Access Compliance Report

Public Rights-of-Way

(Curb Ramps)

Intersection ID: N/A	Main Street: WILLIAMS_POND_LN	Cross Street: N/A	Location: W
ADA ID: 751068E26957	Ramp Type: BlendTrans2	Initial Pass/Fail: Pass	Overall Compliance: No
Severity Score: 2.5			
Codes/Mitigation Info/Possible Solution		Field Measurements/Component Compliance

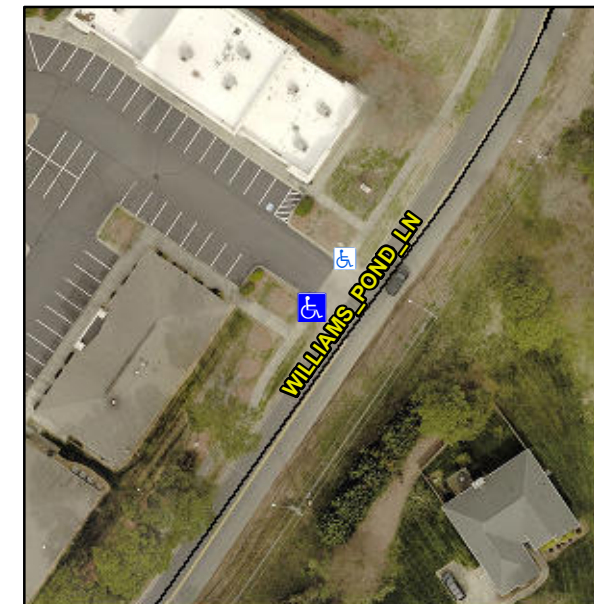
Not Found, R305.1.4

Compliance	Description	Data	Compliance	Description	Data
N/A	Ramp Length (in)	87.0	Yes	BlendTrans Slope (%)	0.7
Yes	Ramp Width (in)	60.0	Yes	BlendTrans XSlope (%)	1.7
N/A	Flare Type LT	Sloped	N/A	Flare Type RT	Sloped
N/A	Flare Slope LT (%)	N/A	N/A	Flare Slope RT (%)	N/A
N/A	Flare Traversable LT?	No	N/A	Flare Traversable RT?	No
N/A	Landing Length (in)	N/A	Yes	DWS Provided?	Yes
N/A	Landing Width (in)	N/A	Yes	DWS Contrast?	Yes
N/A	Landing Slope (%)	N/A	Yes	DWS Length (in)	24.0
N/A	Landing X Slope (%)	N/A	No	DWS Full Width?	No
N/A	Landing Curb? (Y/N)	No	Yes	DWS Offset (in)	0.0
N/A	Shared Landing?	No			
Yes	Gutter Ponding?	No	Yes	Gutter Slope (%)	0.1
Yes	Gutter Lip Ht (in)	0.0	Yes	Gutter X Slope (%)	1.9
N/A	Painted X Walk1?	No	N/A	Painted X Walk2?	N/A
	X Walk 1 Direction	To NE		X Walk 2 Direction	N/A
	X Walk 1 Width (in)	N/A		X Walk 2 Width (in)	N/A
	X Walk 1 Slope (%)	0.2		X Walk 2 Slope (%)	N/A
	X Walk 1 X Slope (%)	0.3		X Walk 2 X Slope (%)	N/A

N/A	Ramp inside XWalk1?	N/A	N/A	Ramp inside XWalk2?	N/A
	Road Slope (%)	0.3		Clear Space?	Yes
	Road X Slope (%)	0.2	N/A	Clear Space to XWalk (in)	N/A
Yes	Any Obstructions?	No	Yes	Storm Grate/Utility Hazard?	No
	Obstruction Type			Storm Grate/Utility Type	
		N/A			N/A
			Yes	Surface Condition? (G/P)	Good
			No	Curb Slope (%)	7.4

Remove & Replace Curb Ramp With Two New Directional Ramps or Equivalent.
